DRAINAGE INFORMATION SHEET

RE: DRAINAGE PLAN FOR MAX CHAVEZ WOODWORKING GALLERY (K-14/D15) ENGINEER'S STAMP DATED JUNE 26, 1987

## DRAINAGE AND GRADING PLAN

INEERII	NG DIVISION		
TITLE:	DRAINAGE		GRADING	PLAN	
MAX	CHAVEZ		DDWORKI		
APPROVALS	ENGINEER	DATE	APPROVALS		7
City Engineer			Liquid Waste	ENGINEER	DATE
A.C.E Design					
			Traffic		
A.C.EHydrolog	ЗУ		Water		
DRAWING		MAA	D NO

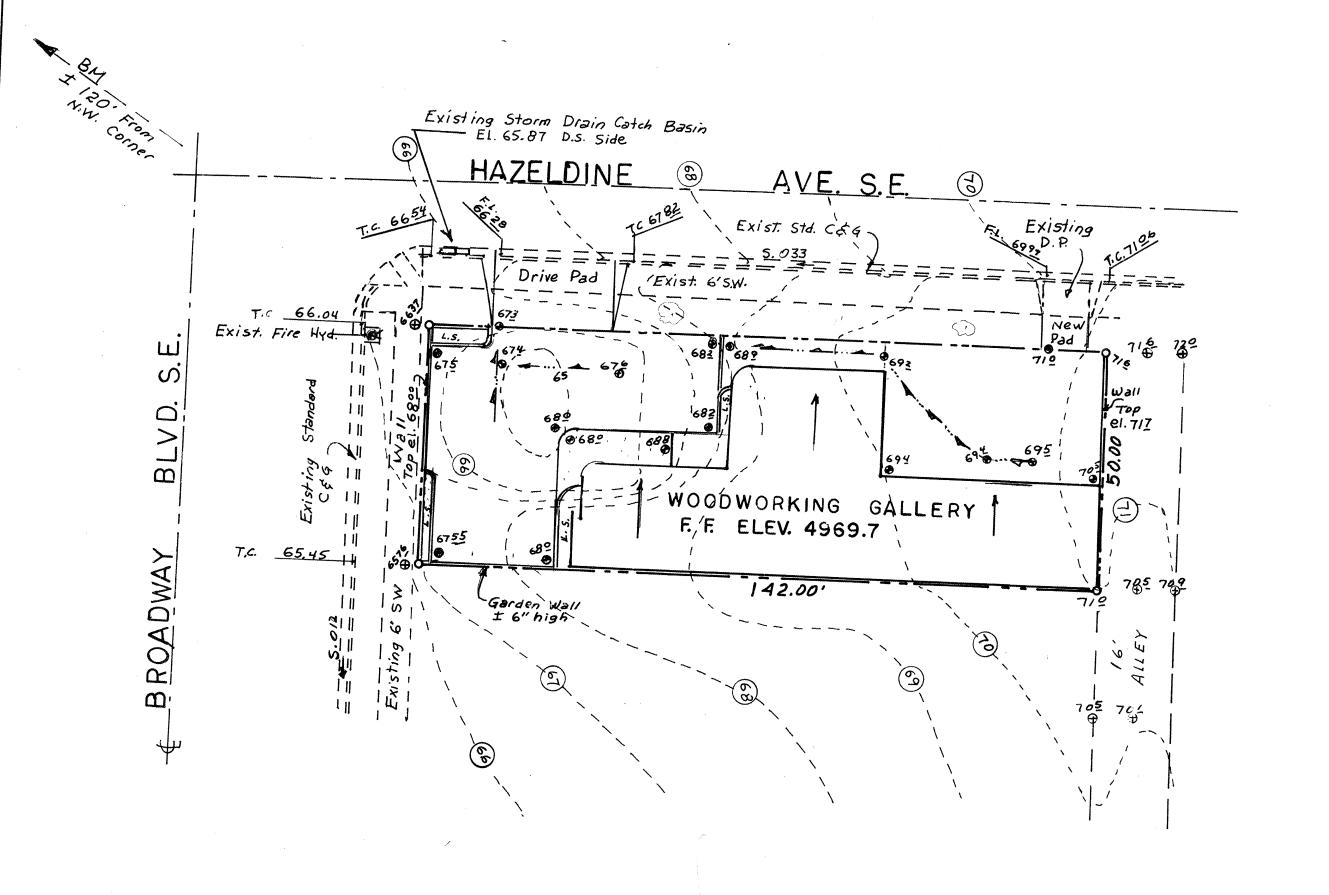
Based on the information provided on your submittal of July 1, 1987, the above referenced plan is approved for Building Permit.

Please be advised that no developed runoff is allowed to cross a public sidewalk. A copy of this plan must be attached to the construction sets prior to sign-off by Hydrology.
